Plumbing and wet-room study · round 1 · inventory, overlay, constraints, scores, alternatives, three scenarios, the utility room · Taif / Palm House V8.1 · STUDY ONLY

Design review E-03, G-07 · open item 10 · 2 Nov 2026 · the latest geometry (the flipped stair, the family bath F-b, the south wing v2, the maid room and kitchen changes, the site plan's manholes and septic route) · **every size is assumed, to be designed by the plumbing engineer** · nothing in the design files changes until the owner decides

OVERLAY · the first-floor wet rooms (green = over a wet / service room, red = over the kitchen) on the ground floor · dots: wet points (blue GF, brown FF) · 1 m = 0.56 cm

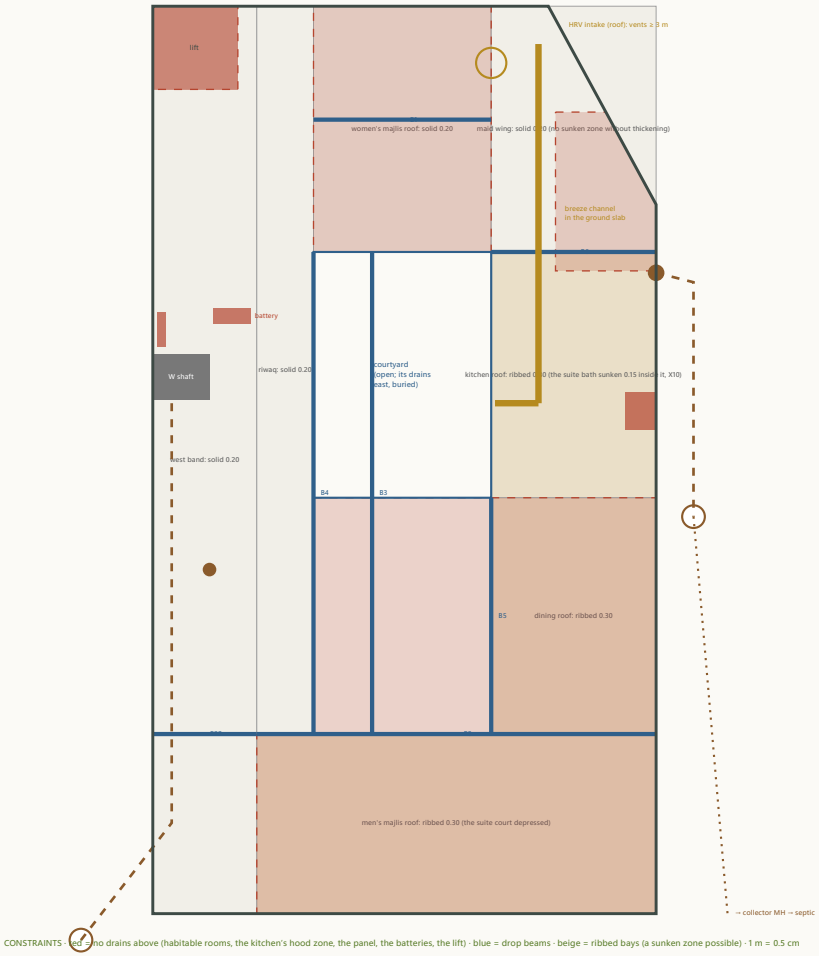
Overlay verdicts

First-floor wet room	Below it	Verdict
Bedroom 2 bath	Utility room (shaft), Hospitality kitchen, Lobby + riwaq	good: over wet / service
Family WC	Utility room (shaft), Lobby + riwaq	good: over wet / service
Bedroom 3 bath	Family powder room	good: over wet / service
Suite bath	Maid room (a bedroom), Laundry, Kitchen	problem: over the kitchen
Suite WC closet	Maid room (a bedroom), Kitchen	problem: over the kitchen

A1 · The suite bathroom over the kitchen · enlarged plans: (a) every drain in the sunken tanked slab (current) · (b) the east service wall + the tub’s plinth

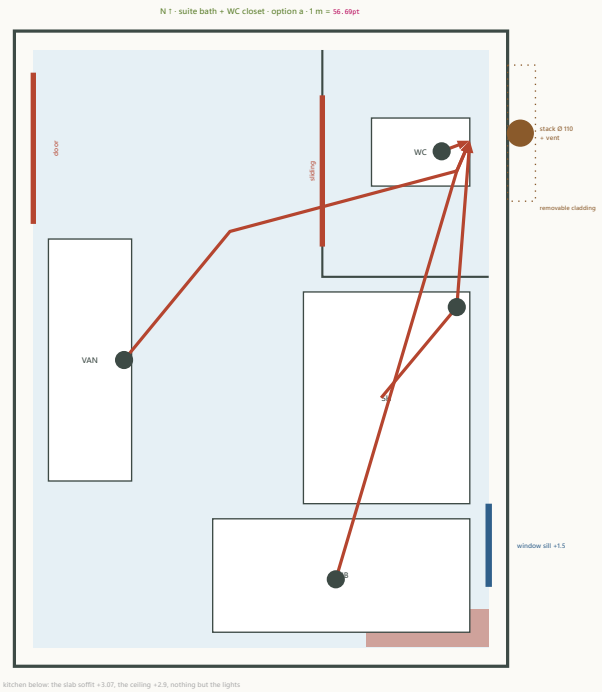
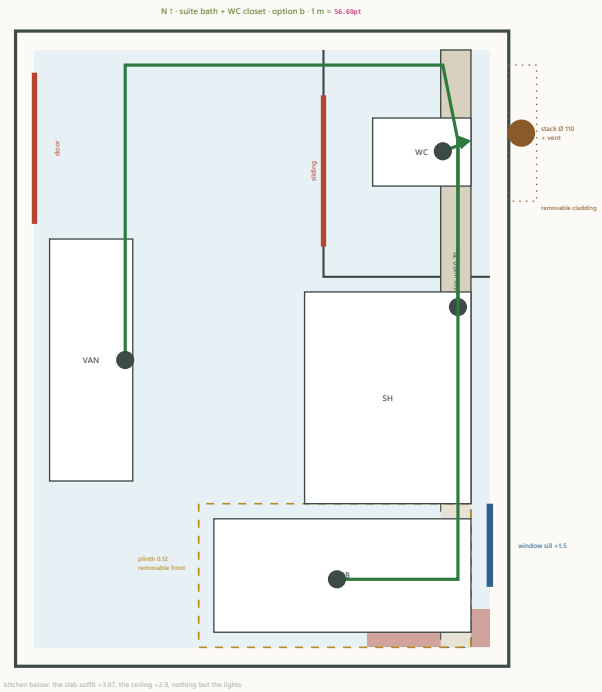
The room and the stack

- The bath x 10.3–13.311, y 6.5–10.45 (3.01 × 3.95 on axes) with the WC closet in its north-east part (12.211–13.311 × 6.5–8.0, sliding door); the **stack outside the east wall** at y 7.05 behind a removable cladding panel, its branch fittings at the first-floor level, its vent to the roof; the **east window** y 9.5–10.05 (sill +1.5); the **hood zone** of the kitchen below starts at y 10.2 on the east wall: the depressed slab reaches y 10.45 but **no drain runs south of y 10.15** (the tub’s outlet at y 10 checked).
- **Fixtures** (`studies/ff_suite.typ`): the WC in the closet on the east wall (its outlet 0.2 m from the wall), the walk-in shower on the east wall y 8.1–9.5, the freestanding tub on the south wall by the window (its waste at x 12.3), the double vanity on the west wall (its trap 2.9 m from the stack by the floor route).

(a) all in the sunken tanked slab (current, red)

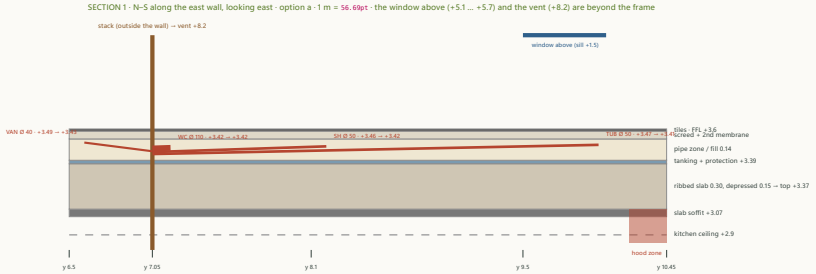
- The ribbed slab’s top is depressed 0.15 over the whole bath (+3.37); the build-up from it: the tanking membrane and its protection screed (+3.39), the **pipe zone 0.14 m**, a lightweight fill, the 50 mm screed, the second membrane under the tiles, the tiles (+3.6). The four drains lie in the fill at 2 % to the east wall and pass through it into the stack’s branches: all four fit (page 8), the WC’s Ø 110 with 0.02 m and the tub’s flat trap on its diagonal with 0.02 m to spare at the stack: tight.
- **Buried:** the WC’s bend, the shower’s gully and its outlet, the tub’s trap and its 3.1 m outlet, the vanity’s 3 m outlet and every joint of them. Reached only by lifting tiles, screed and the second membrane; the tanking under them stays.

- **(a):** the pipe zone is 0.14 m; the WC's Ø 110 (an S-trap pan, its bend 0.07 under the tiles) fits with 0.02 m to spare over its 0.19 m run; the shower gully (0.09 body) and the vanity (0.07 bend) fit with 0.03 and 0.04 m to spare; **the tub fits only with a flat 0.08 trap on the straight diagonal under the shower** (0.02 m to spare): at the limit of the build-up, with a 0.10 trap or a run along the walls it does not fit at 2 %. Nothing hangs under the slab: **the kitchen ceiling carries only the lights** (the soffit +3.07 under the depressed zone, the gypsum at +2.9): also in (a). But every drain and joint is under 0.07 m of screed, membrane and tile.

(b) the east service wall + the tub’s plinth (green)

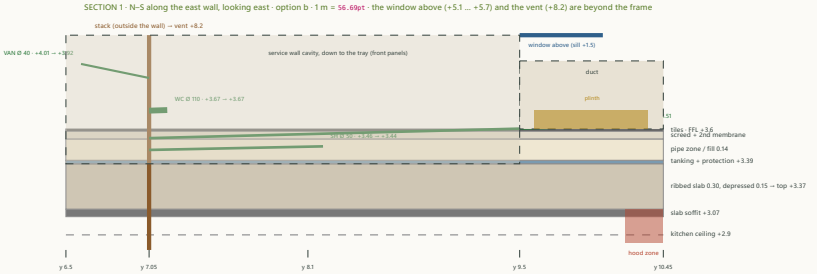
- A **0.20 m service wall** inside the east wall from the closet to the shower’s end (y 6.5–9.5, full height, its cavity down to the depressed slab), continued as a **0.45 m high duct** under the window to the south wall; the **WC wall-hung** on the wall’s frame with its outlet **horizontal at +0.18 straight through the wall into the stack** (0 m of floor pipe); the **shower channel along the service wall with its trap body inside the wall cavity**; the **tub on a 0.12 m plinth with a removable front** (its trap in the plinth’s void above the floor; the pipe in the plinth, the duct and the wall to the stack, 3.79 m at 2 %, arriving at +3.51, at about the floor level inside the wall cavity, 0.14 m above the tray); the **vanity’s Ø 40 in a chase in the north wall at +0.45** (one jointless pipe from its bottle trap) into the service wall. **What still lies in the floor:** the shower channel’s body only (set in the screed at the wall, its trap in the wall). Note: the door on the west wall (y 6.65–7.65) is not touched; the chase runs behind the plaster above the skirting.

- **(b):** no pipe below the tiles except the channel's body (0.10 deep in the screed, at the wall); the WC's outlet at +0.18, the channel's trap at +3.51 in the cavity, the tub's pipe from +3.62 to +3.51, the vanity's chase from +0.45 to +3.92: all above the tray, reached from the room side.

- **(b)**: the east service wall with the wall-hung WC, the wall-drain shower channel and the tub's plinth; the vanity's jointless chase. Every drain, trap and joint but one is reached from the room side or from the stack's cladding outside without cutting a finish; **the one exception is the shower channel's body** (its insert, strainer and seal come out from the front; the body itself, if it ever fails, needs a local opening ≈ 1.4 × 0.3 m of tiles and screed along the wall and the membrane re-made there, the tray below untouched). That is the smallest opening in the room and the best practical compromise: a channel body is a passive part with no moving element.

- **Keep the depressed tanked slab** in (b) too: it holds the channel's depth and is the second line against any leak; the cavity's weep and a tell-tale show a leak before it spreads. The kitchen ceiling under the bath carries nothing.

(c) a raised floor with removable panels

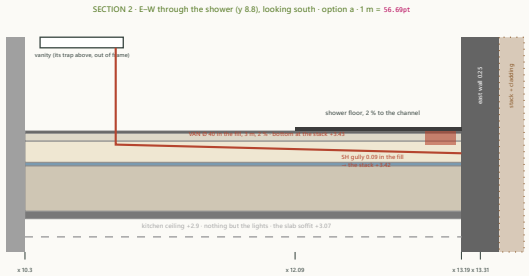
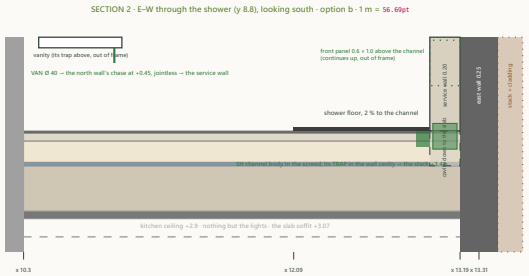
- A floor on pedestals over the tanked slab with lift-out tiles is practical only where no water falls on it: it cannot be sealed and removable at once in the shower. It works for the **tub’s zone** (= the plinth of (b)) and for a **dry strip along the west wall** under the vanity (0.6 wide, lift-out stone slabs over the vanity’s pipe): used in (b) as the plinth; the west strip is an option if the owner prefers the vanity’s pipe in the floor to a wall chase.
